Site Inspection for Basewide Investigation of PFAS
Former HPNS, San Francisco, California

The enclosed technical memorandum provides our technical rationale for the installation of an extraction well (EX-11) as the next step in implementing a solution for addressing the methane levels associated with GMP-07A. To continue forward progress, it is tentatively planned to install the extraction well the week of February 22, 2024 weather permitting.

FIFTH FIVE-YEAR REVIEW REPORT
HUNTERS POINT NAVAL SHIPYARD, SAN FRANCISCO, CALIFORNIA

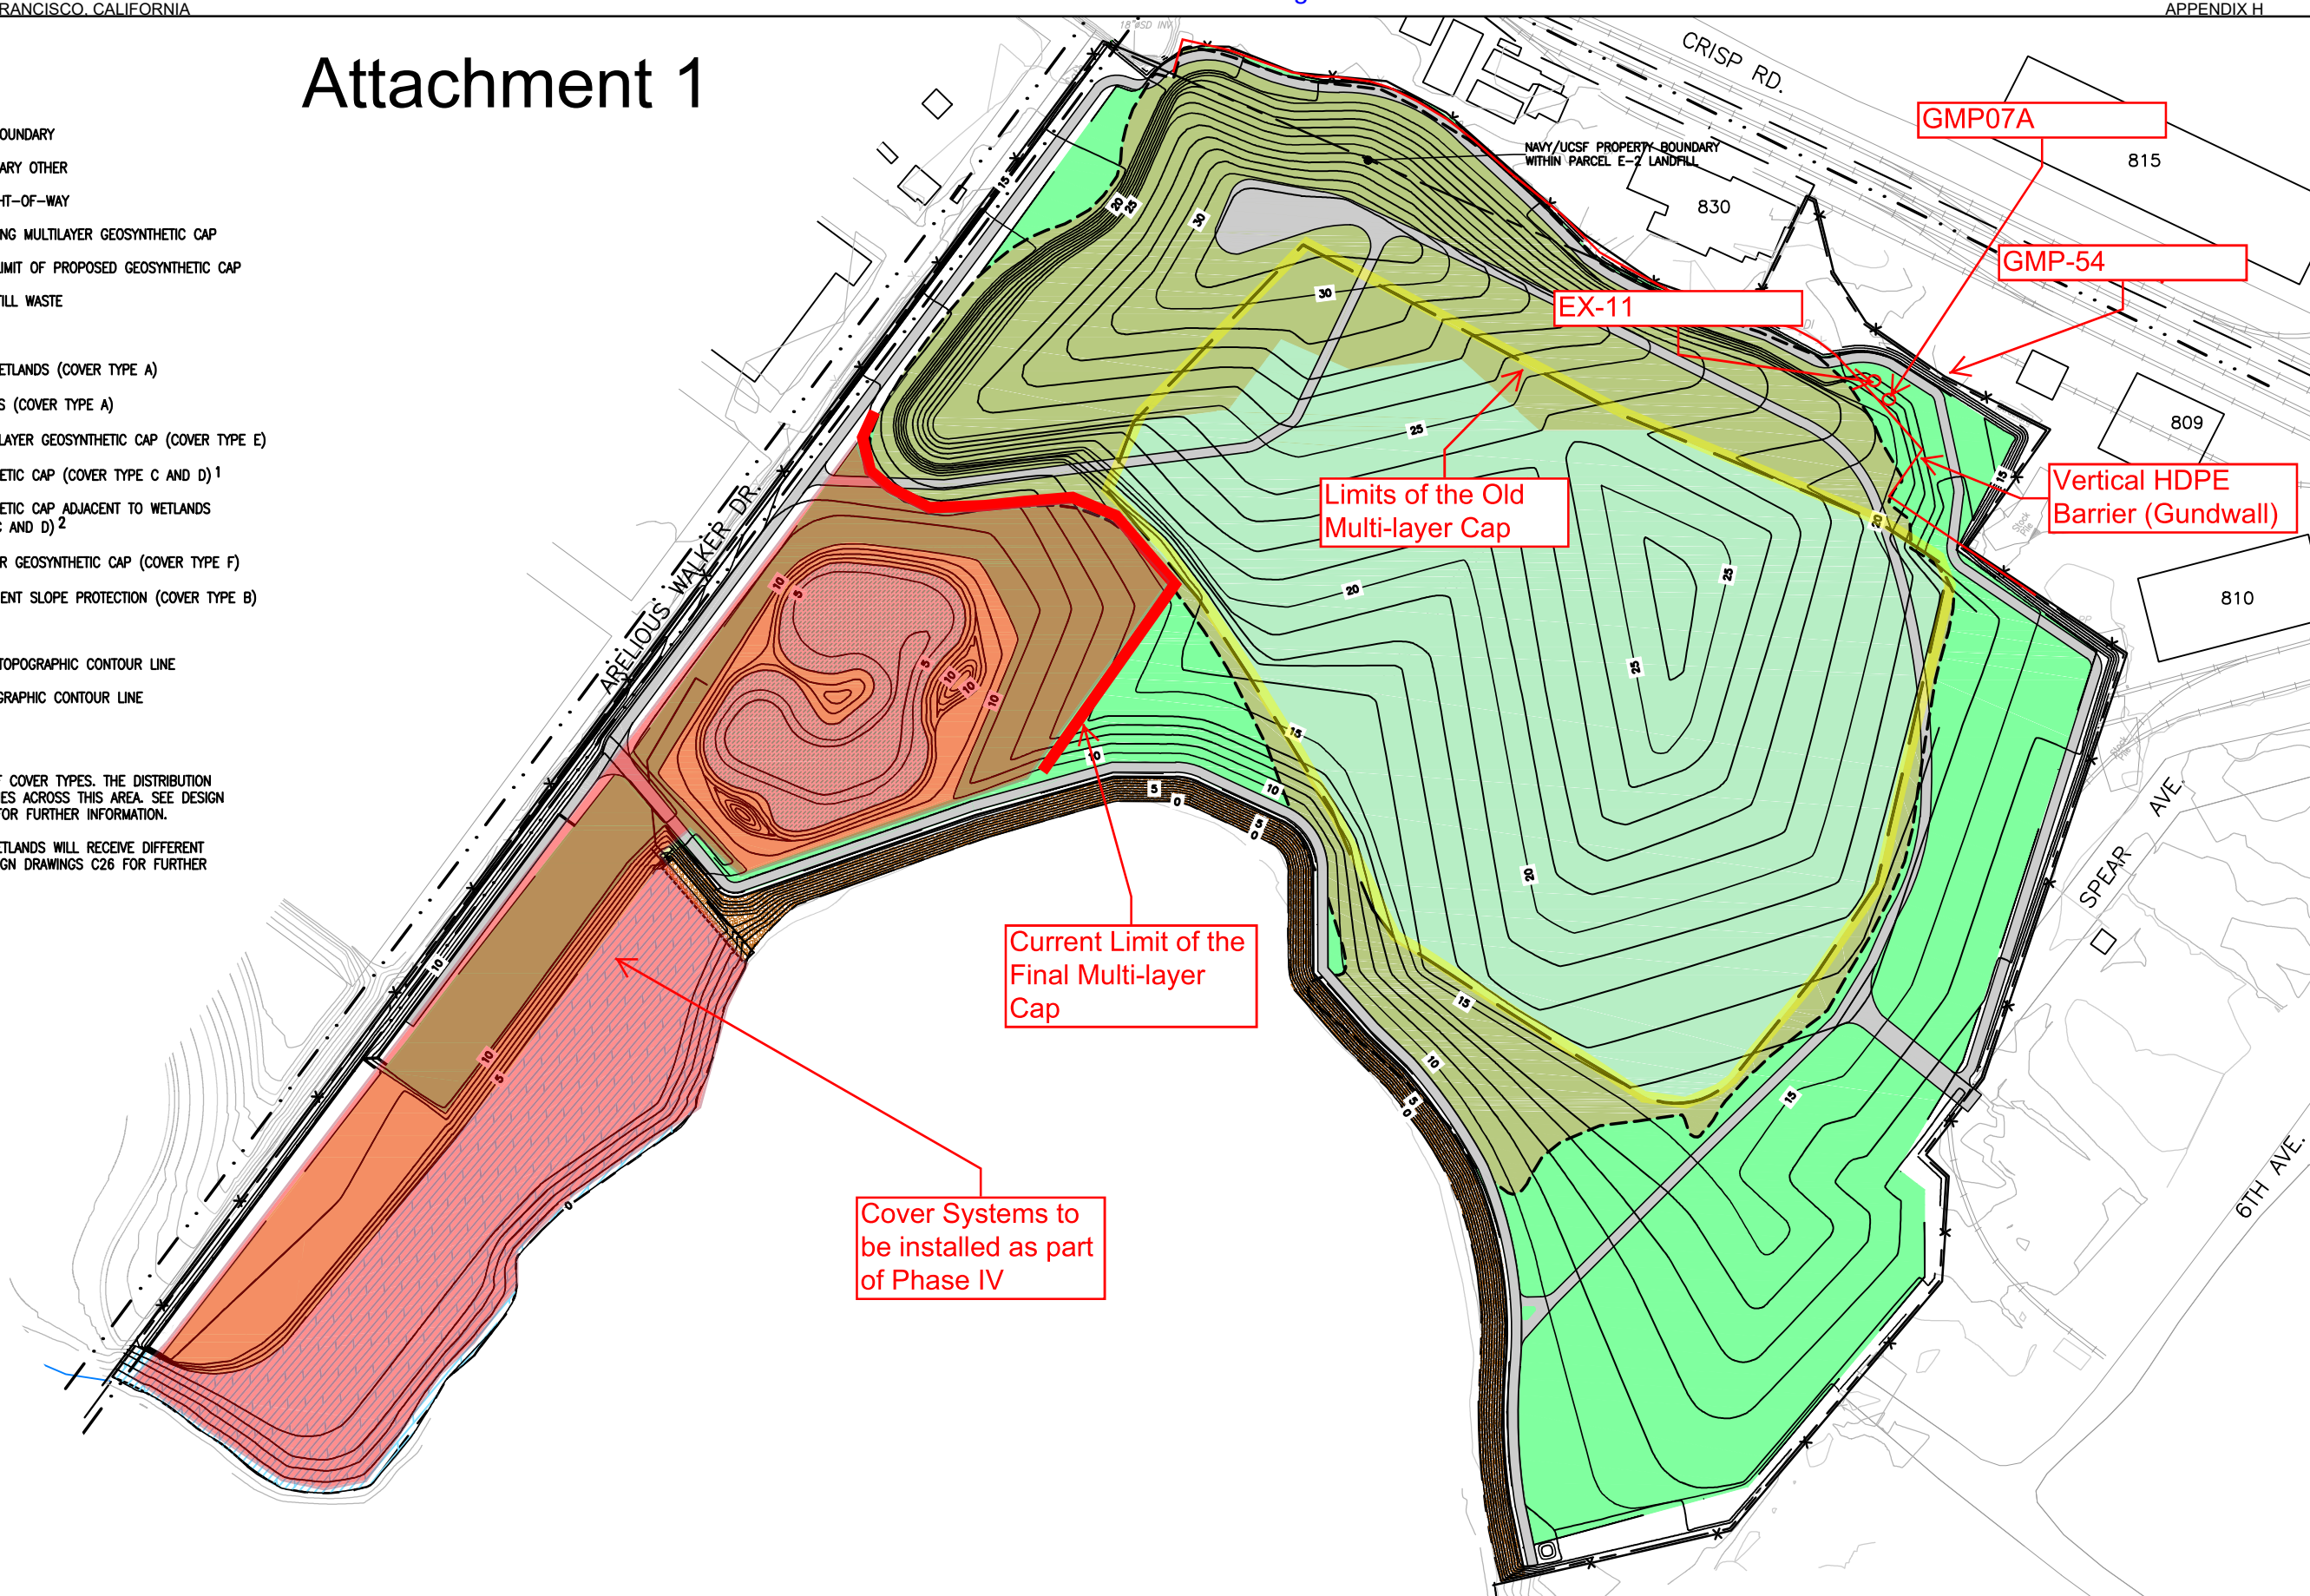
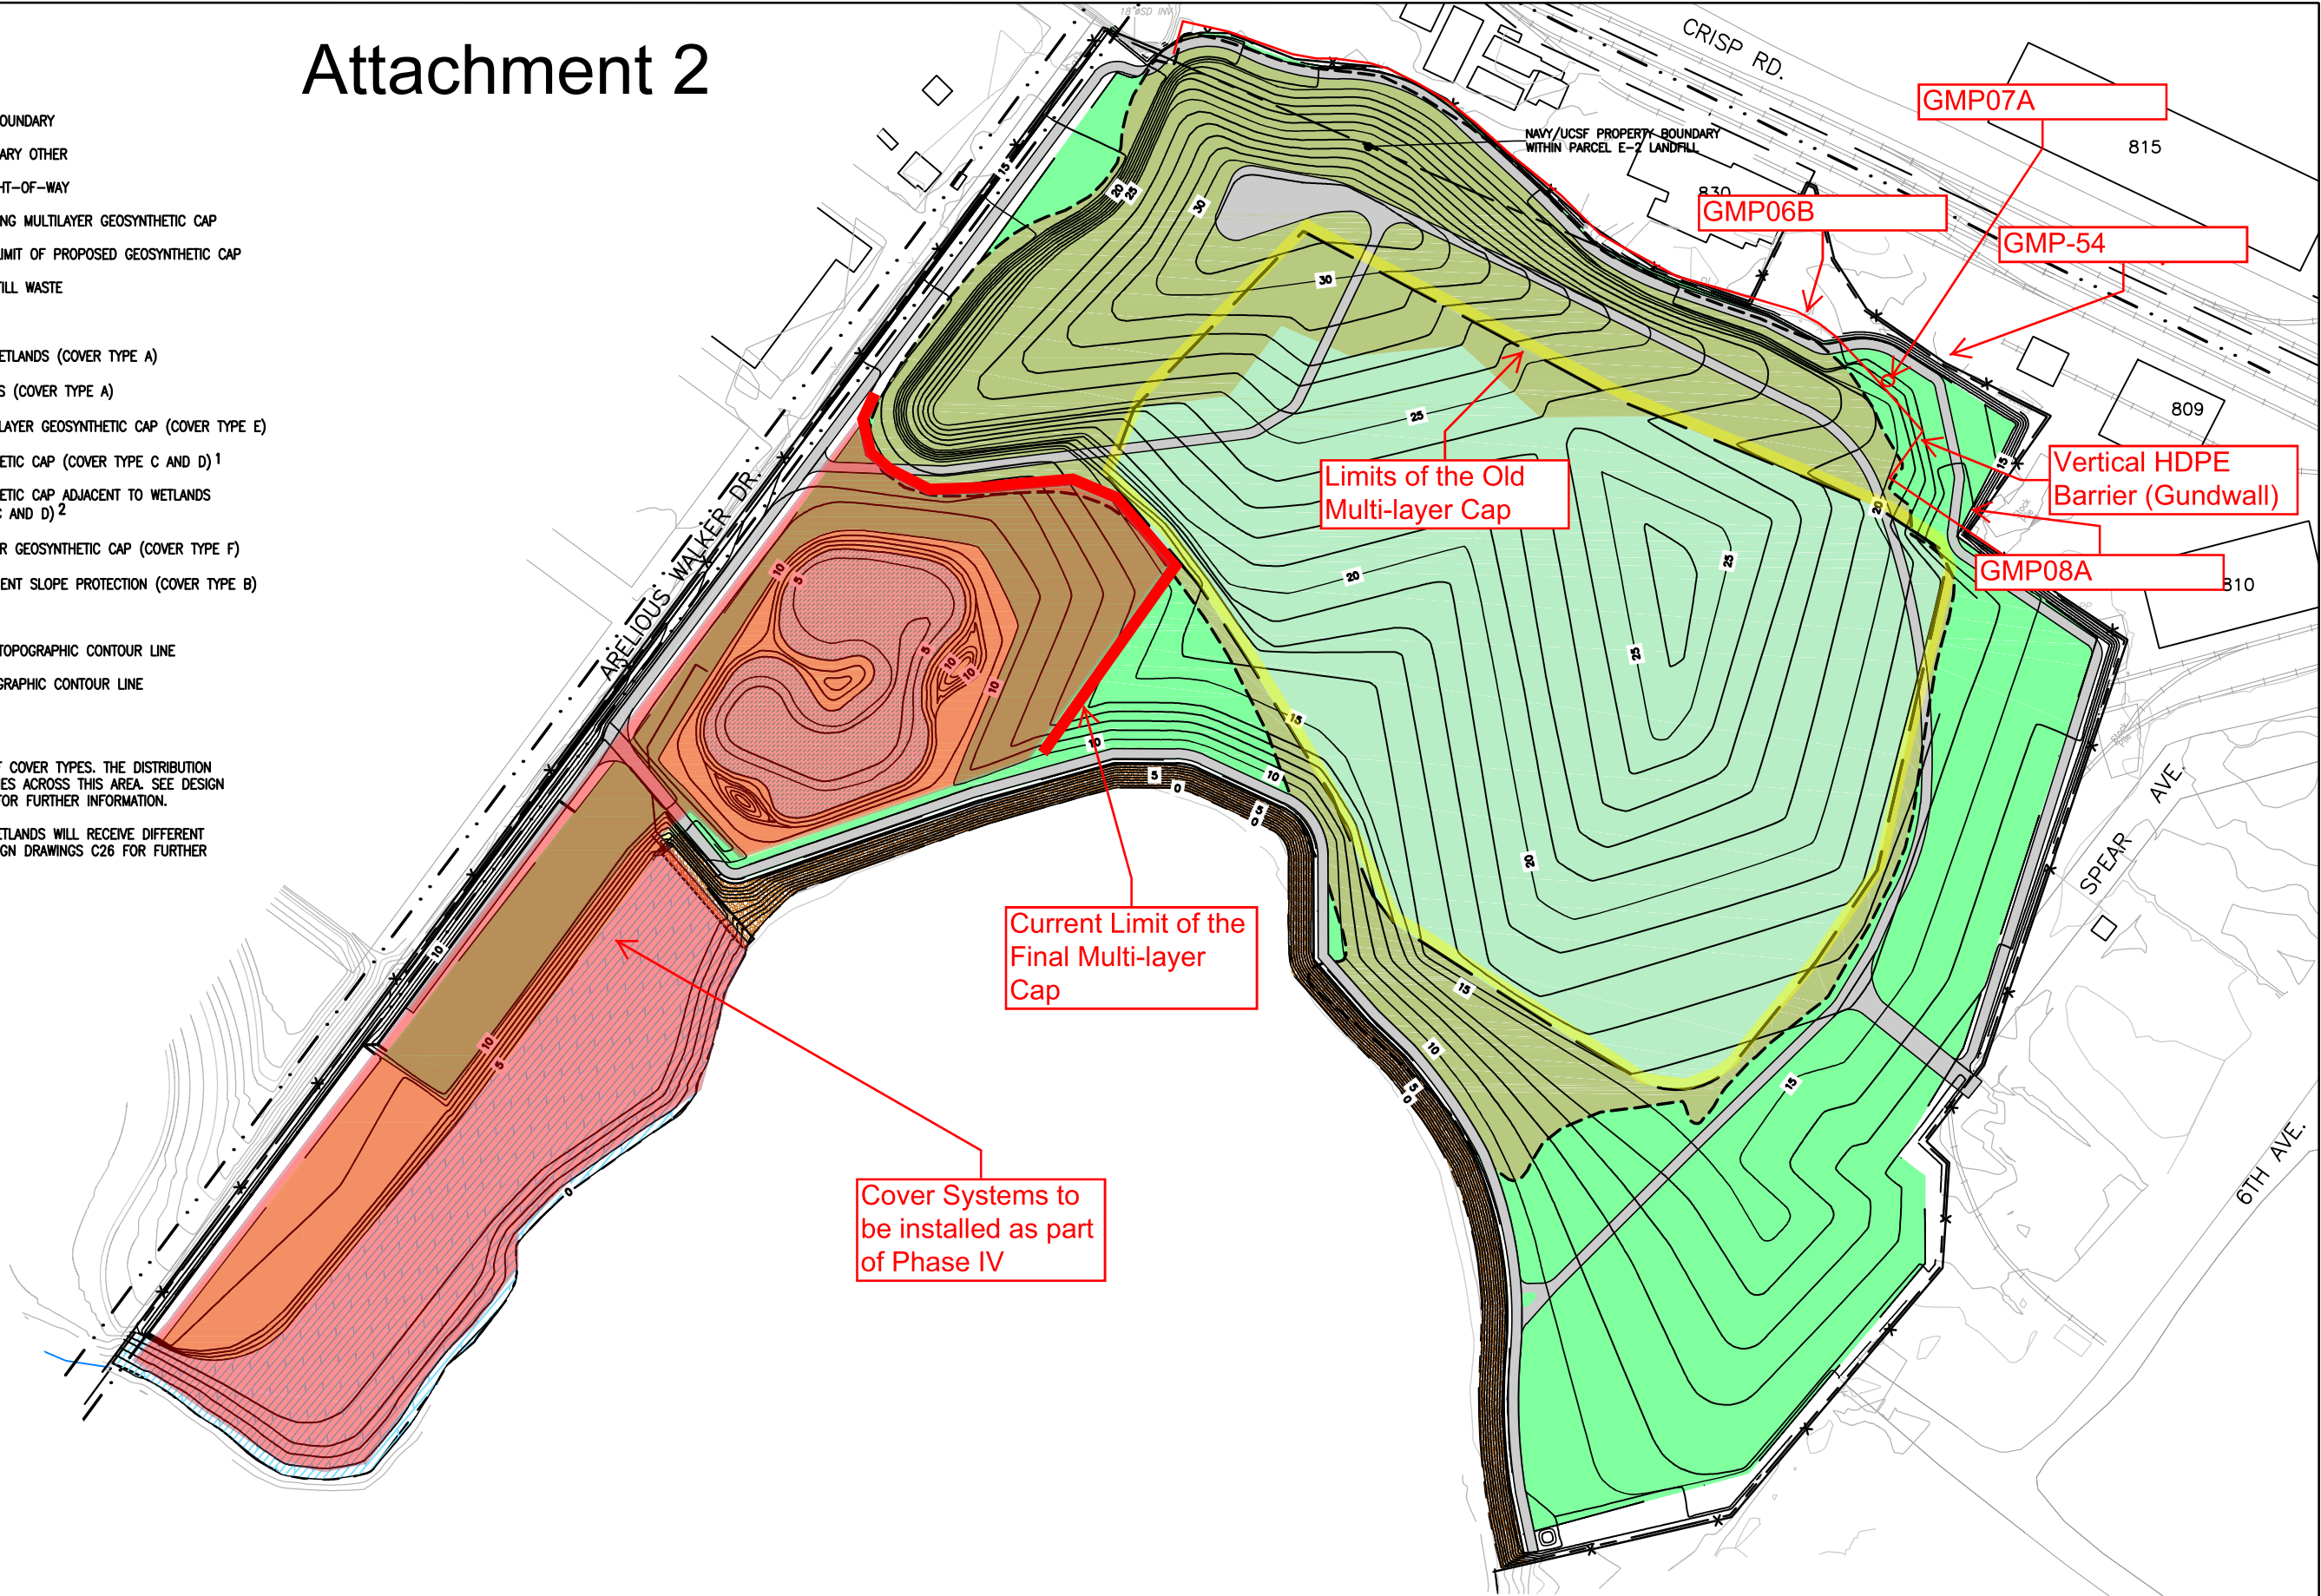
The extraction well will be installed on the week of February 22, 2024, on the Parcel E-2 Landfill within the geomembrane boundary, approximately 20 feet from GMP-07A (Attachment 1). The installation of this extraction well is in response to the methane levels at GMP-07A and will be incorporated into the long-term methane control solution portion of the approved remedy. The Navy will continue to work with the regulatory agencies to develop and implement a long-term strategy for the methane levels at GMP-07A.

- Installation of EX-11 in the area of GMP-07A will allow the mobile extraction unit to be attached and lower the methane concentrations in that area to protect human health and the environment, in accordance with the Final Interim Monitoring and Control Plan Section 2.2.2 Gas extraction Units and Treatment System (Attachment 2).

Figure 1: Meta Fix Injection and Rejection Locations (Source: Figure 6 Draft RACSR)

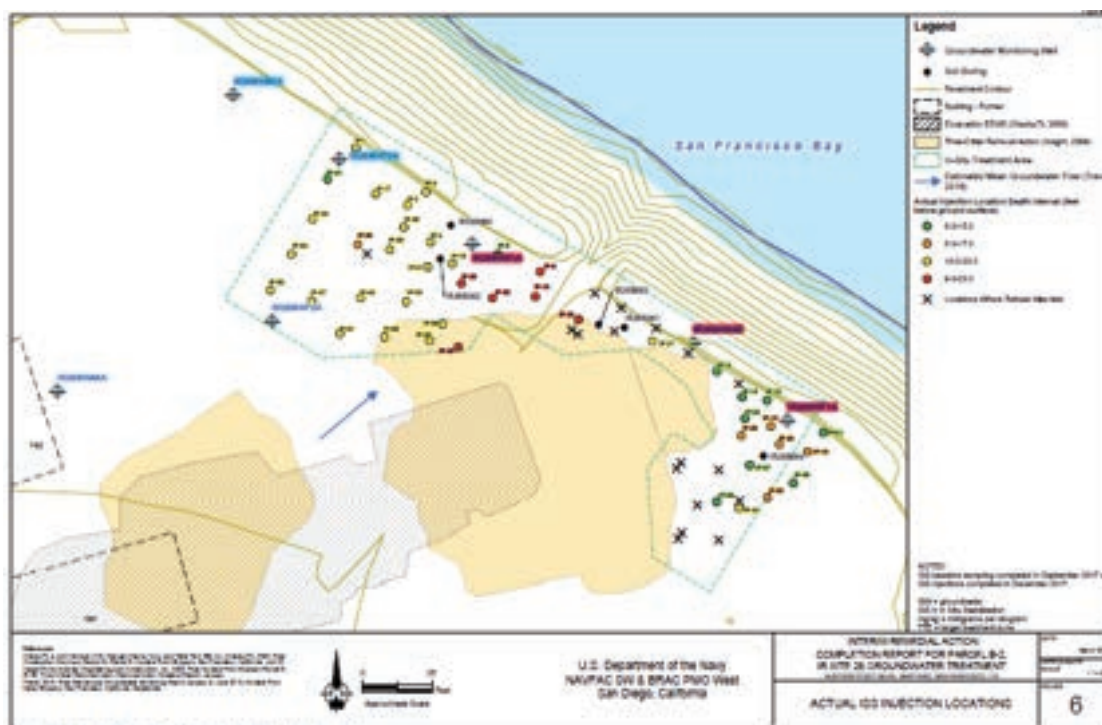
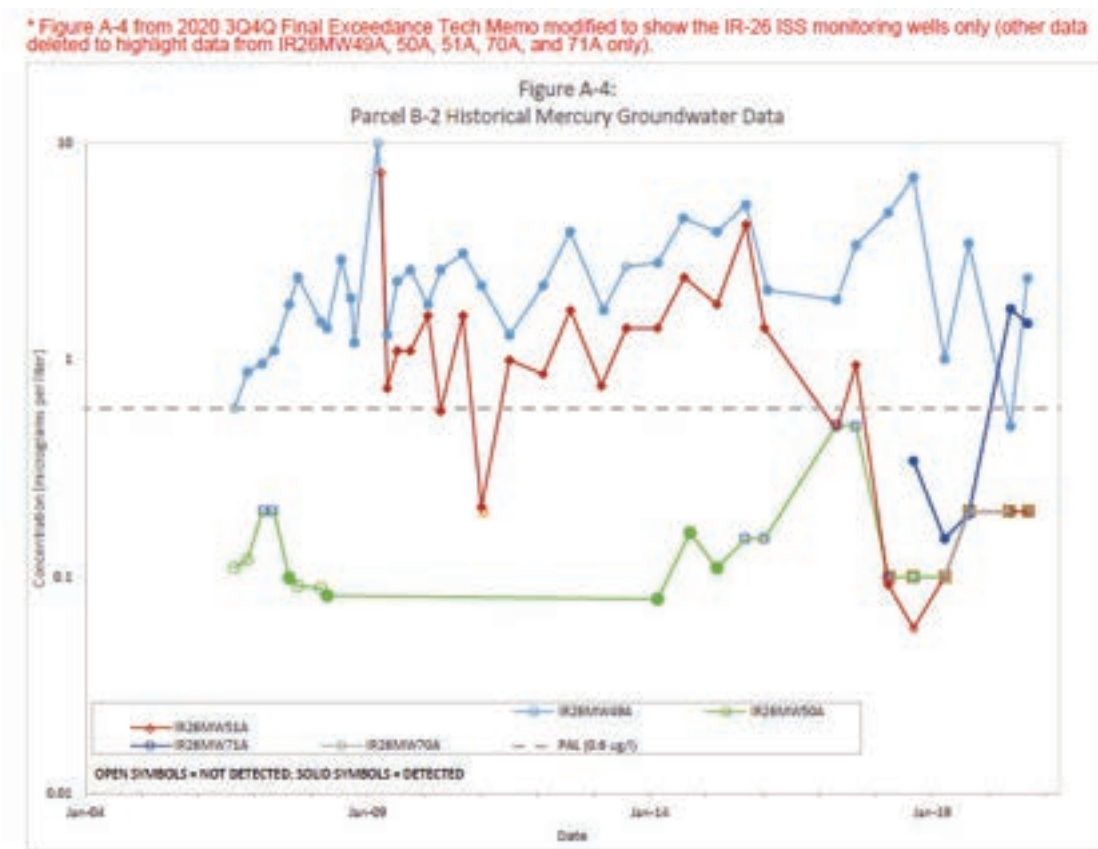
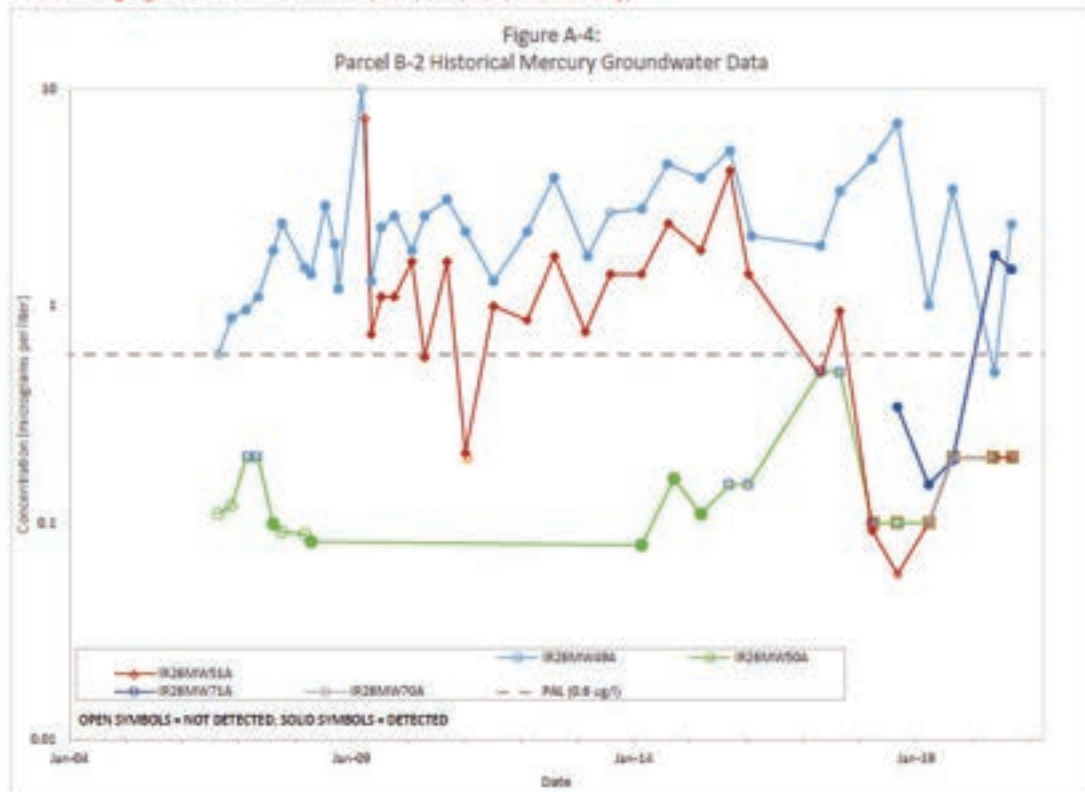
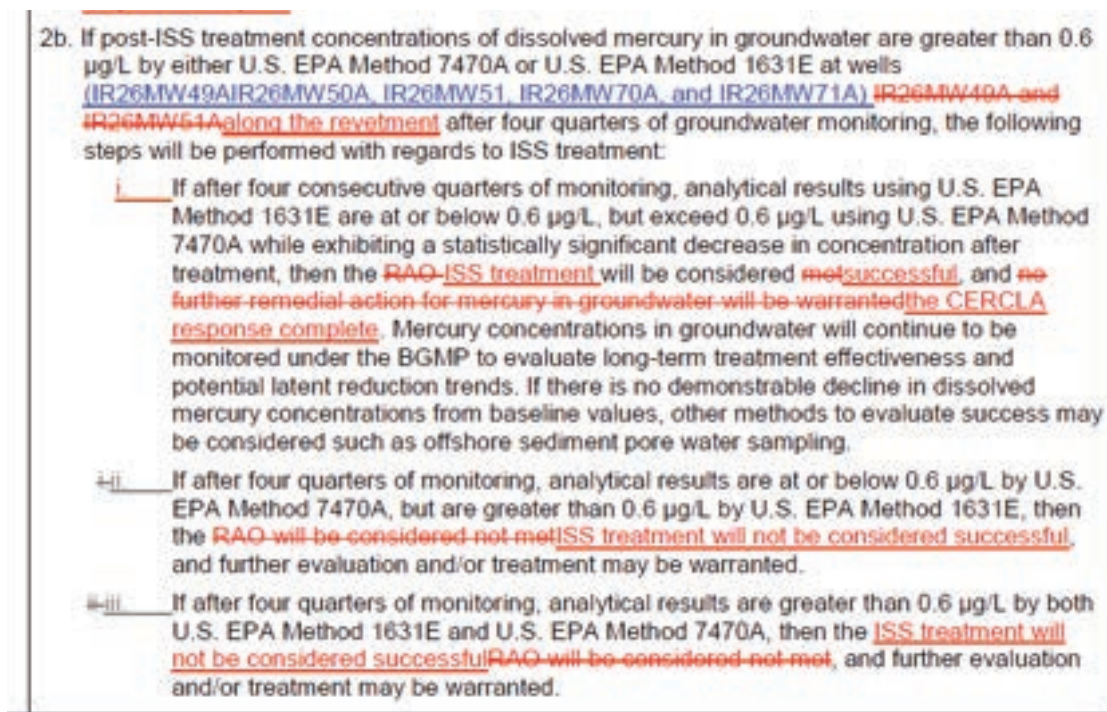
In sum, the ISS treatment has failed as a treatment technology to achieve the desired results. See Figure 2, Table 1, and Figure 3 presented again, below, for convenience.

In accordance with the Navy's own protocol, above, the ISS treatment has not proven successful and "further evaluation and/or treatment may be warranted."
